**Regarding: Environmental Impact Report prepared for the Banning Ranch Project and the construction of a major road through a very sensitive Coastal Bluff Habitat**

Section 4.3 GEOLOGY AND SOILS

# WEST NEWPORT OIL FIELD

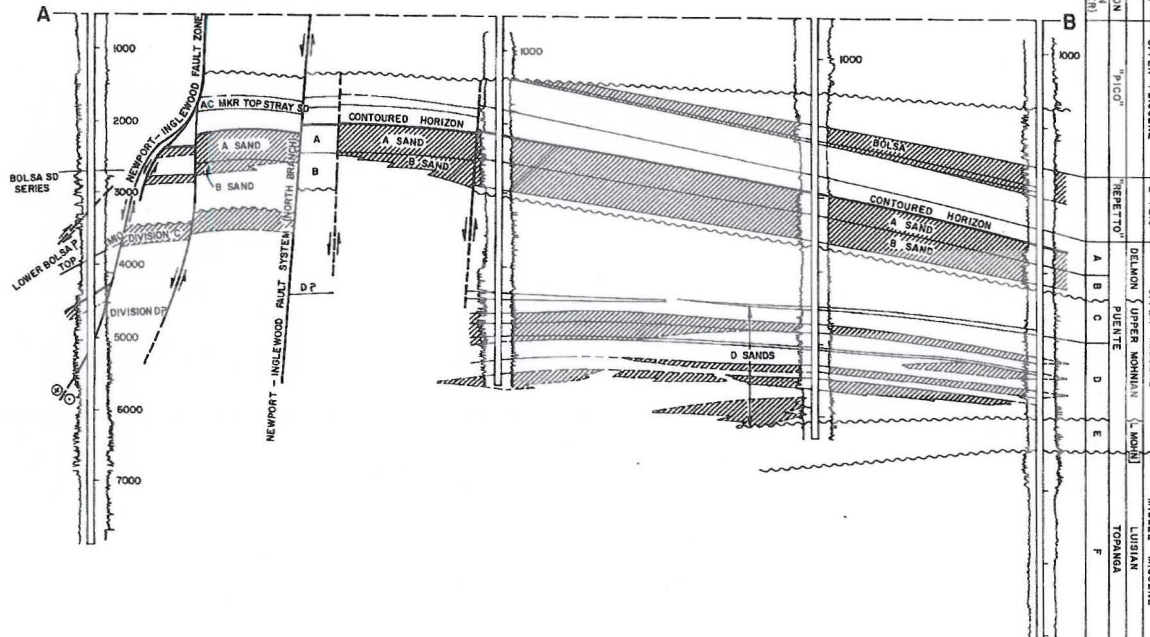
I am very puzzled about how the City of Newport Beach ended-up operating the remaining active oil wells. When I used to work for the Division of Oil and Gas and Geothermal Resources. All oil wells have to have bonds that assure proper plugging if they are shut-in (idle) for more than 5 years. Most of the 489 wells would be played out (non-productive) years ago if the field started producing in the 1940s, and according to California Conservation Law the wells should have been plugged and the well sites restored years ago. In addition, if the majority of the 489 wells are plugged and abandoned as required, were they plugged and abandoned to the current criteria for wells in areas that will be subject to urban development? I wouldn't want to live over an old oilfield that has oil wells that haven't been abandoned to urban criteria (concrete from bottom to top). Some of the wells intersect fault planes and could be sheared by any significant fault movement. I have attached maps and cross-sections of the Newport and West Newport Oilfields from Report No. TR12 "California Oil and Gas Fields, Volume II, South, Central and Coastal Offshore California. Numerous Newport-Inglewood fault traces are shown extending from depth to the surface in the West
